D-Motor International bvba

Service Bulletin NO. 2019-014/2

SUBJECT : Alternator Flywheel modifications (improvements) Version 2

MODELS AFFECTED : All models on LF26 and LF39 engines**TIME OF COMPLIANCE :** from 11/06/2019, or when due to service**AFFECTED SERIAL NUMBER(S) :** See (*)**Scope :**

ECO (Egineering Change Order)

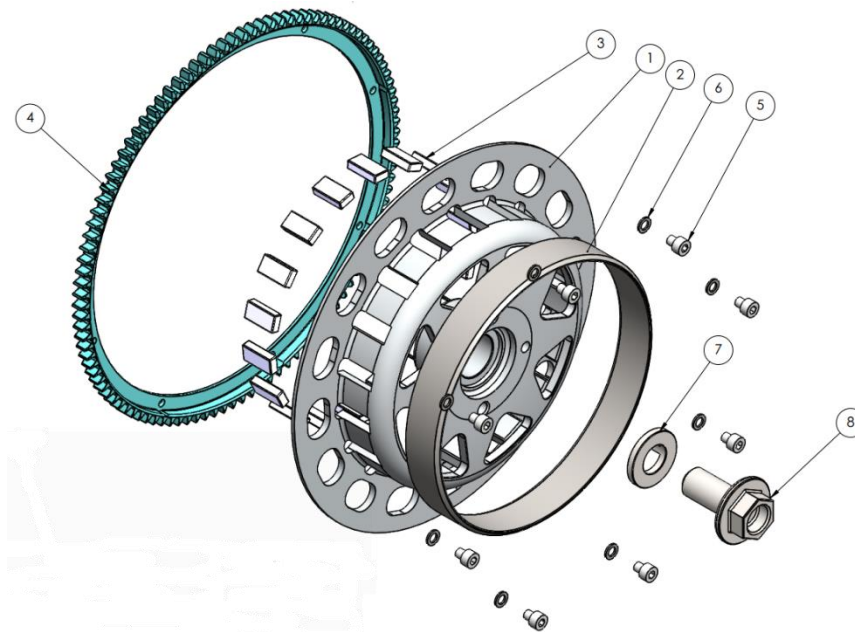
The openings on the Flywheel are triangular now, instead of trapezoidal.
The body is thicker.

The Stator plate has changed

(*) M16X1.25 / M16X1.5 Bolt

Depending on the Serial number of the Cranckshaft, the bolt dimensions are

If S/N starts with 'FAR' the Bolt to use is M16X1.25

If S/N is NOT FAR, the bolt to use is M16X1.5

Bolt tension : 110 Nm – in case of doubt, contact our technical department

CAUTION : The Stator plate has changed as well !

Do not use the 'old' stator plate

Fixation :

- glue (Loctite 648) on magnets when mounting
- mount with press
- shorten M5 bolts after mounting

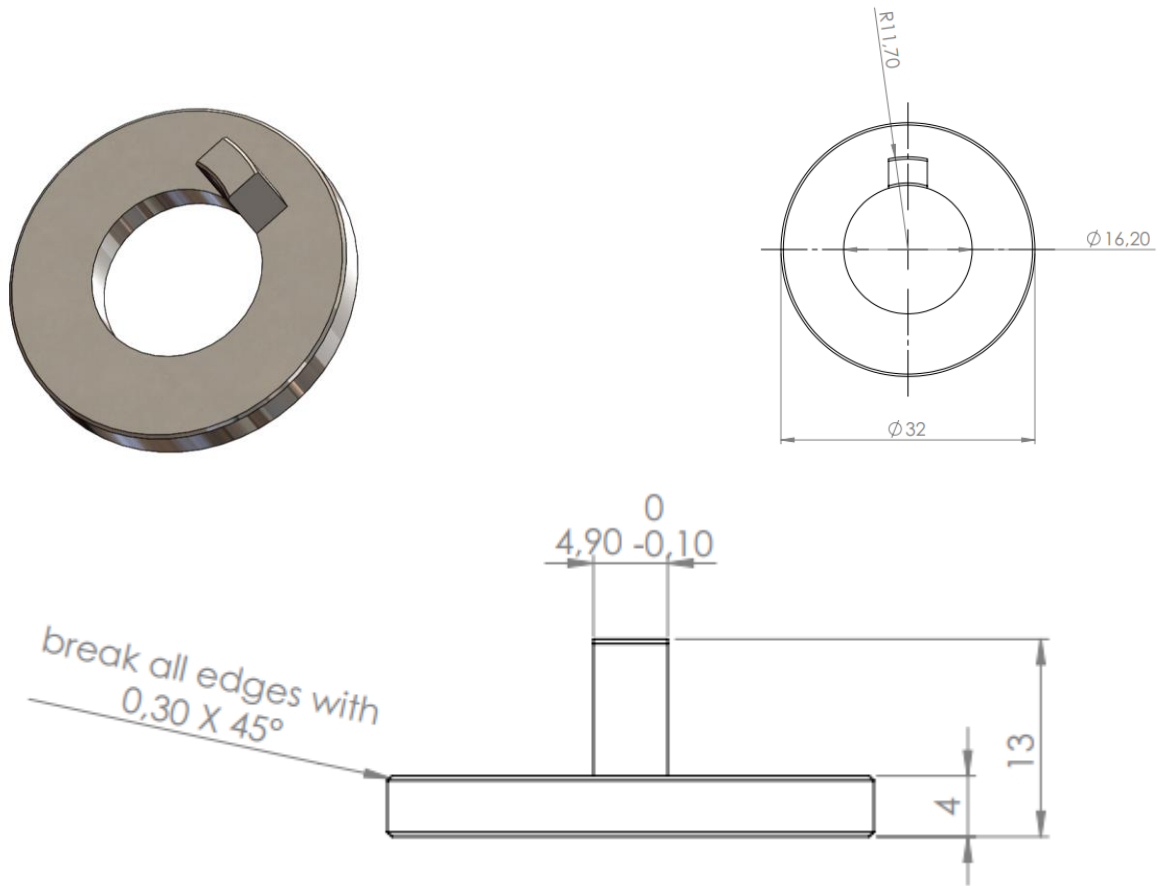
Fixation of the wheel (1) on the backplate body : use special washer (D-Motor made) –
STD_ALT_WASHER_01

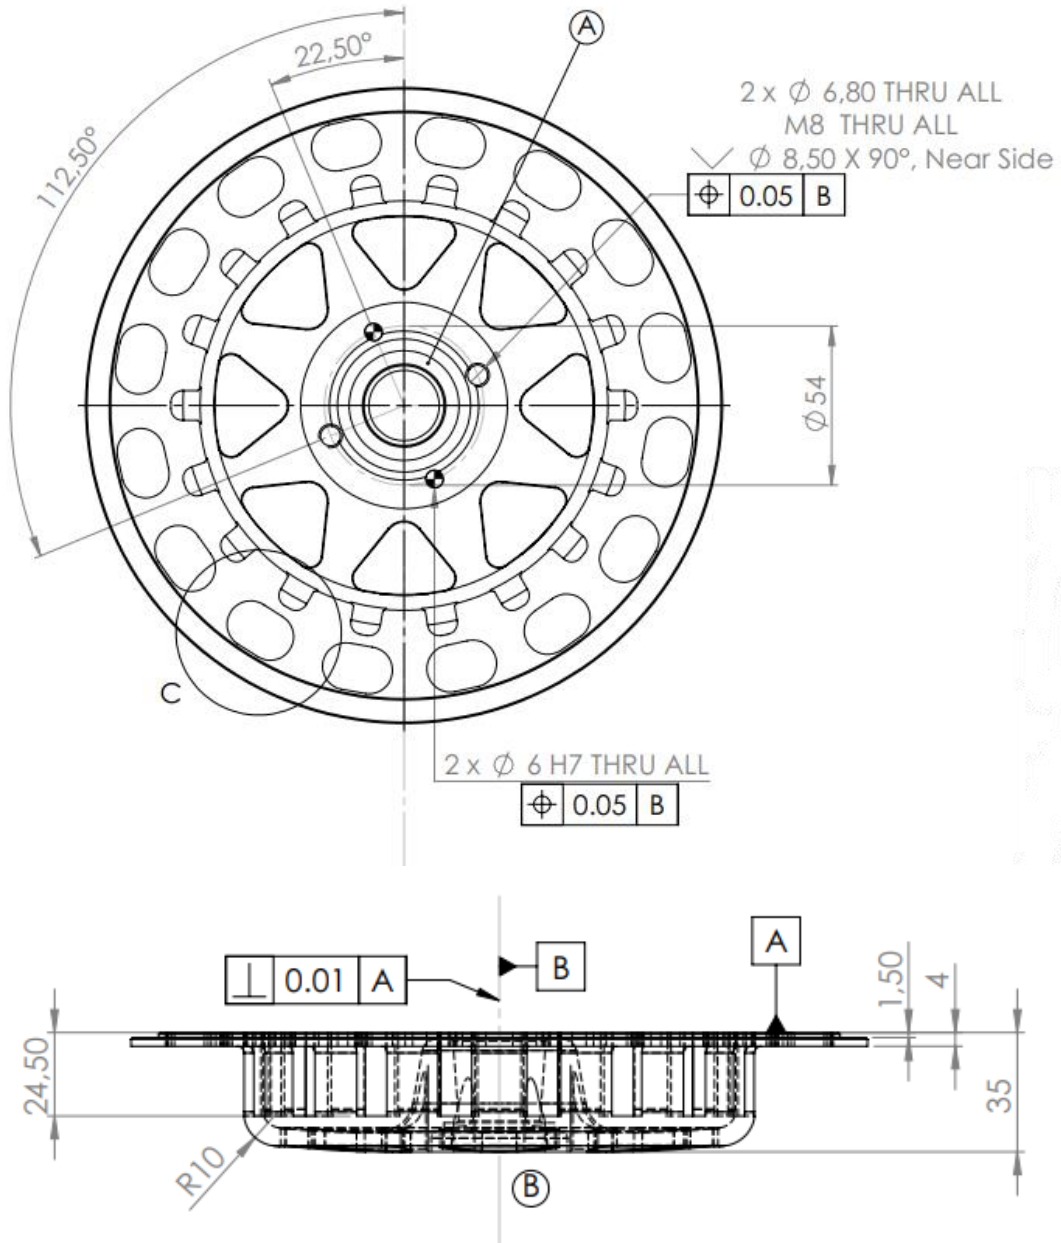
REVISIONS				
ZONE	REV.	DESCRIPTION	DATE	APPROVED
E6	A	Front face of cone is brought back with 2mm	11/03/2019	PDE
A7	B	chamber of Ø32.5 with a depth of 2.5mm is added	11/06/2019	PDE

Exploded ASSEMBLY of the modified Alternator Flywheel

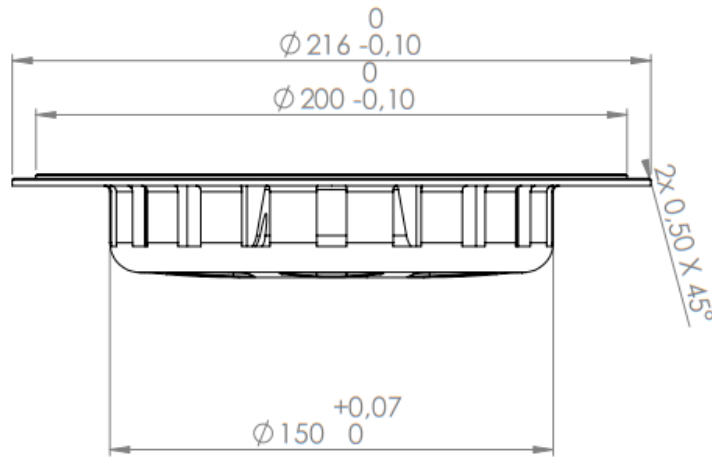
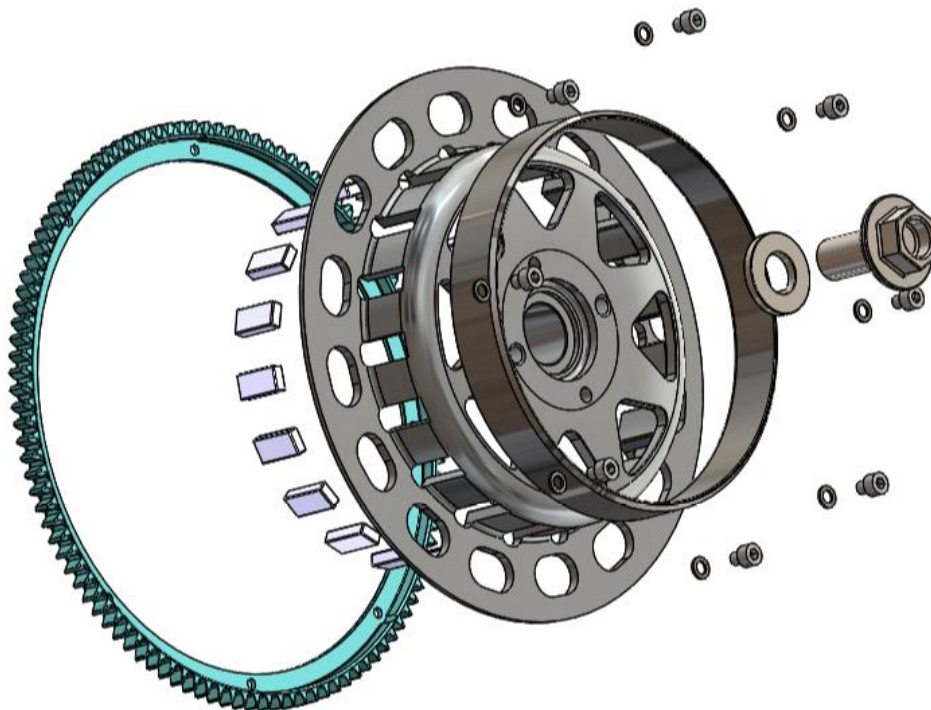
The FlyWheel (alternator) structure was modified (structure). the new model is stronger and more resistant to large forces. The fixation was changed. (new special washer added)

Alternator Stator (fixation plate to be changed) :

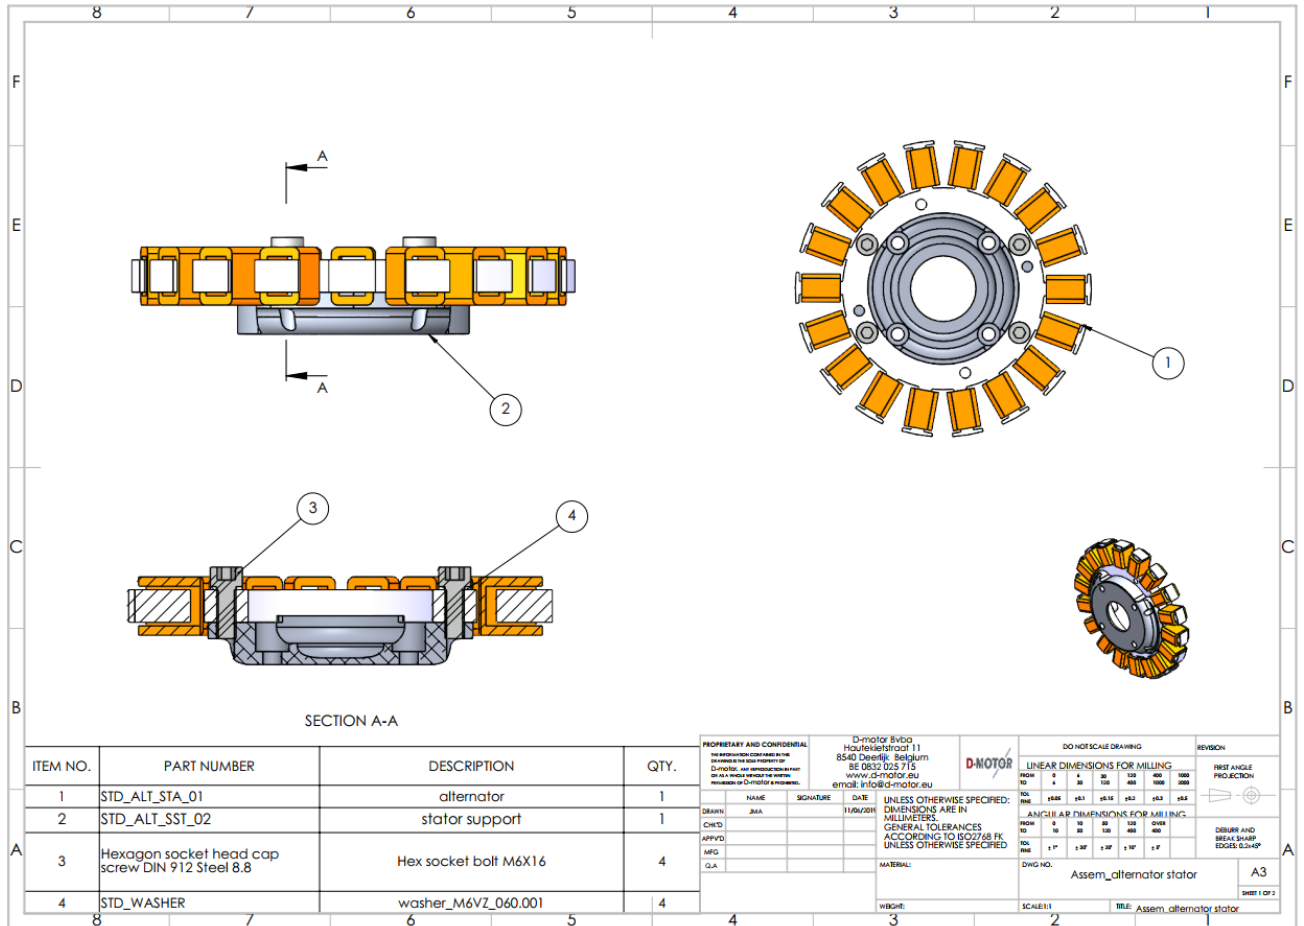
Modification of the Alternator Coil :

- >> The flywheel structure is thicker, the fixation plate Coil ↔ Backplate is thicker
- >> The cabling that enters the coil set should change side !!! (in order to prevent damage to the cabling set)

Wiring change path for the coil wires :

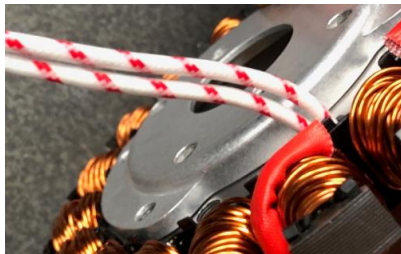
OLD Fixation plate

NEW Fixation plate

NEW FIXATION PLATE

OLD FIXATION PLATE

- 1/ disconnect the wiring from connector or box
- 2/ change the wiring from the top side (the side the flywheel is covering the coil set) and guide it to the opposite direction.
- 3/ mount the thicker plate (fixation plate coil – backplate) on the backplate, and mount the coil on the fixation plate, connect the coil wiring again

Change of side wiring :

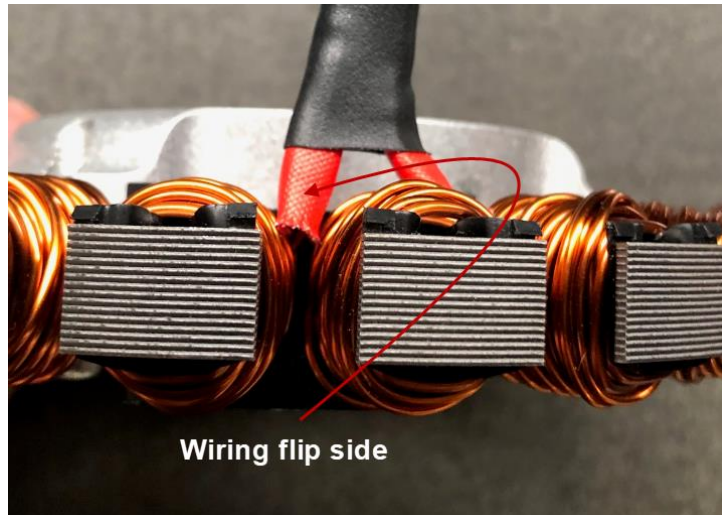
- Get the existing wiring out of the black glider
- Pull back the two generator coil wires to the other side
- Isolate (see red and black isolation) again and mount the coil on the backplate fixation plate
- Connect the wires to the engine again (by connector or box)
